# Product Change Notice: 3M™ High Routability Internal miniSAS HD Cable Assemblies – Latch Change

Issue Number: 915

Date: April 6, 2015

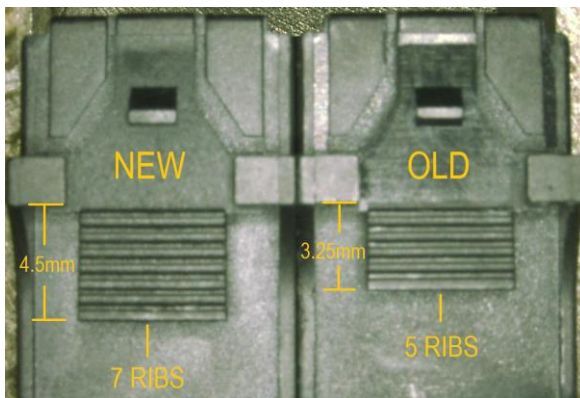
Effective immediately, latches for all 3M High Routability Internal miniSAS HD Cable assemblies will be shipped in a modified condition, extending the length of the latch by 1.25 mm. This is not a dimension placed on the customer drawings, but under close observation, the change would be apparent. On the previous latch, there were 5 ribs. On the new latch, there are 7 ribs.

This change is designed to enhance the accessibility of the latch. Functionality is not changed. Part numbers and customer drawings are not impacted. Below is an image showing the differences.
